## Paragon II Platform

Release 4.4.1

August 4, 2008

The following picture represents the supported configuration (in this example, the 4-port model is used):

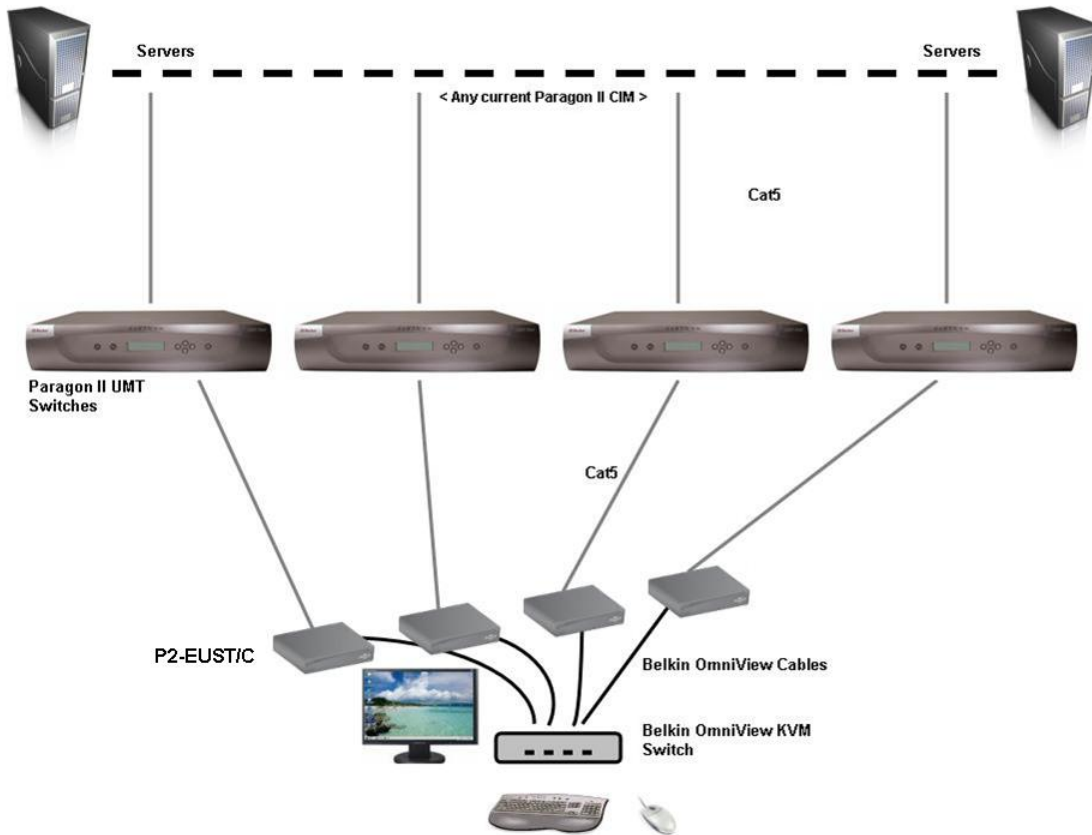
4.4.1 provides compatibility with the Belkin OmniView™ Secure KVM Switch. The approved configuration allows for the use of the Belkin switch as a “front end” to the **P2-EUST/C**, in which the switch’s special KVM cables are connected to the Paragon user station (note that the Belkin switch is not compatible with the **P2-EUST**). Each of the Belkin OmniView models is supported:

Use of the P2-EUST/C card reader is supported with this configuration, however, the card must be reinserted each time a new server is accessed.
